TOWN OF COTTAGE GROVE
PLAN COMMISSION MINUTES
APRIL 24, 2024

- 8) David Riesop, petitioner, Kennedy Hills, LLC, property owner: DCPREZ-2024-12048 to rezone 47.6 acres from AT-35 to SFR-08 to create 50 additional residential lots in the Kennedy Hills subdivision: David Riesop was present, as was Realtor David Dinkel, who did most of the talking. He noted that Phase 1 lots are all sold, and they are ready to proceed with the next two phases, proposed to be a total of 50 lots depicted by the concept plan he distributed (Exhibit A). This concept plan is slightly different than the one approved by the Town back in 2018, which only had a total of 64 lots, not 66, and showed

Concept Plan

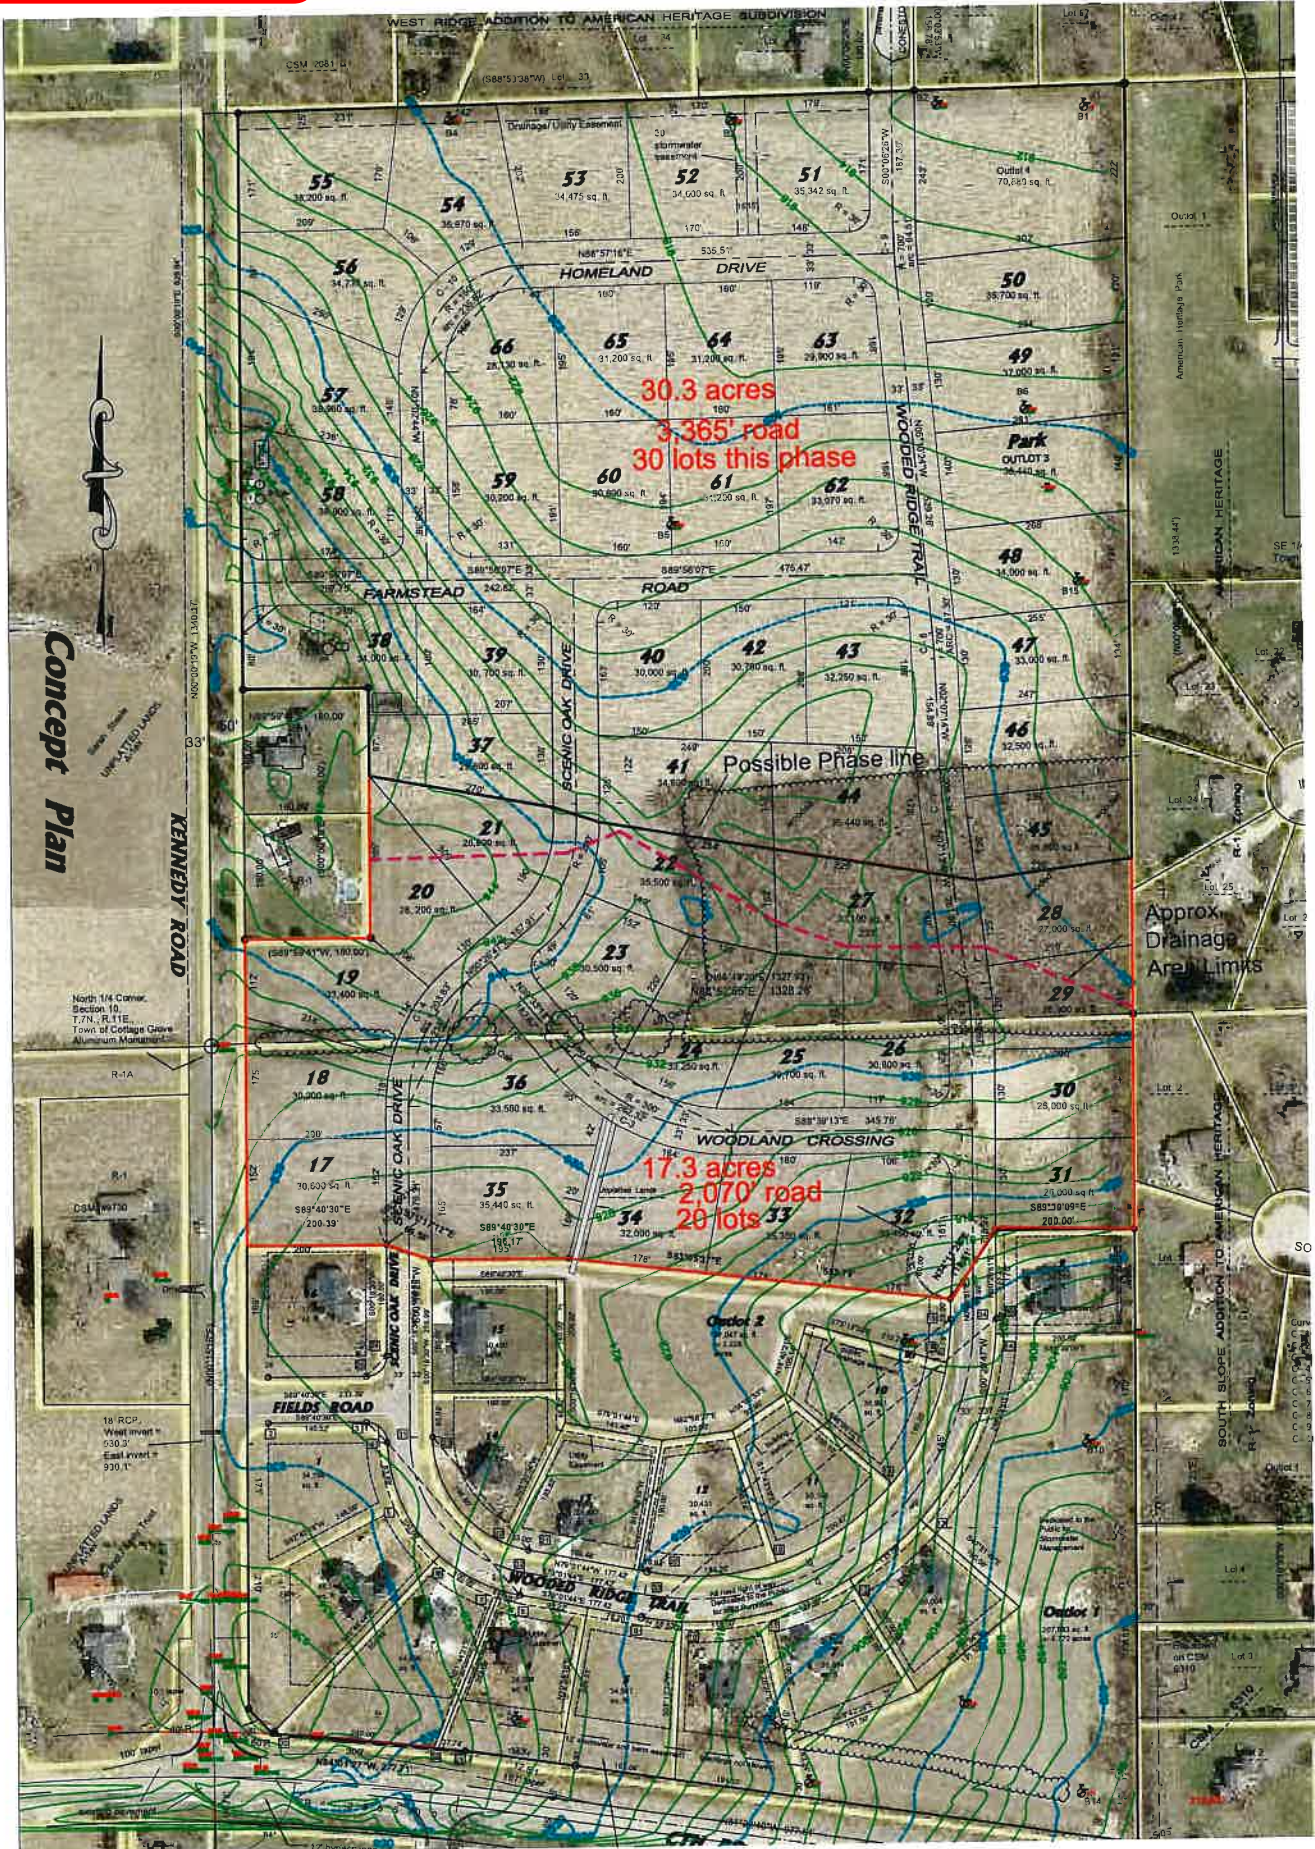
Mr. Dinkel mentioned the wooded area and stated that efforts would be made to incorporate the trees into the lots there. He also noted that they had seen comments from the Town Engineer and Planner about needing Woodland Trail and Farmstead Road to be 70' wide.

Hampton said that lot 55 would be a problem with its driveway on Kennedy Road being too close to the Whiting Road intersection. Suggestions were to either give it a driveway on Homeland Drive or eliminate it and make lots 54 and 56 larger.

- Dan Koppes, 2165 Independence Circle, expressed concerns about increased traffic at the Kennedy Road/CTH BB intersection, as well as water coming over the hill from the wooded area toward his property. He also asked why the parking lot planned for Outlot 3 was not centered on Sr. Dan Johnson Memorial Park, which it would be intended to serve based on a Parks Committee recommendation for the original concept plan.

- Jeff Page, 2166 Independence Circle, thinks the parking lot would be better placed where lot 49 or 50 are shown, noting that if it was at lot 50, it would only affect one homeowner.

MOTION by Anders/Eickhoff to recommend approval of the rezone of 47.6 acres from AT-35 to SFR-08 to create up to 50 additional residential lots in the Kennedy Hills subdivision, contingent on the appropriate number of RDUs being acquired before zoning is final, and including a requirement that the distance between the northern tax parcel and the closest Village of Cottage Grove property be measured to see if it meets the policy stated in item 3. under *Relationship to the Town's TDR Program* in Figure 8 of the *Visions and Directions* volume of the Town's Comprehensive Plan. (RDUs required would either be 6.25 for the entire 50 lots proposed, or two for the 12 lots in the southern parcel if the ¼ mile policy is met by the northern parcel.) **MOTION CARRIED 6-1** (Hampton opposed).
